May 21, 2024

Wind Point Homeowners Association Clubhouse

Wind Point, WI

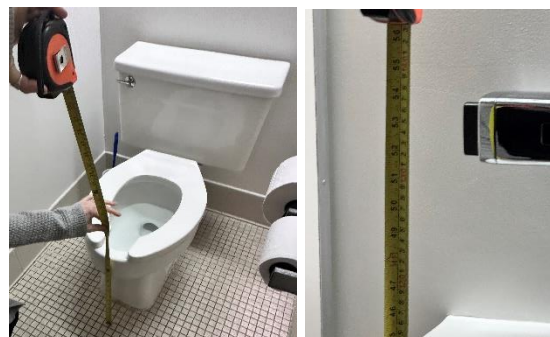
Barrier 14: The men and women restrooms on the clubhouse ground floor have the most non-compliant features in the building. Only a few dimensions were taken of the restrooms after verifying critical measurements, i.e. – clear door width, door swing into required open spaces for maneuvering, pathway width from door to stalls.

The men and women restroom doors have a clearance of approximately 27 inches, a minimum of 32 inches is required. Maneuvering to exit the restroom has many challenges. The restrooms do not meet the required 18-inch parallel doorway clearance and 48-inch perpendicular doorway clearance. It would be difficult for a mobility device user to exit the restrooms independently if at all.

A 60-inch turning space is required in the restrooms; the restrooms are approximately 76 inches wide. The 30 inches by 48 inches open spaces for each fixture can overlap 25 inches within the required turning space. Turning radius of 60 inches with the remaining 5 inches (after the 25 inches from 30 inches open space width at fixture) leaves only 11 inches for fixtures (toilets, sinks, urinals).

Recommendation: The men and women toilet rooms are approximately 74-inches wide, removing the separately wall would provide approximately a 13 foot wide single use toilet room. Below is a simple layout of a possible single use toilet room, after demo'ing the current men and women restrooms. The single use restroom layout includes a toilet, sink, and changing table all with a 30-inch by 48-inch open spaces, a 36-in door, and a 60-inch turning radius. Not depicted is an urinal that can be included within the restroom.
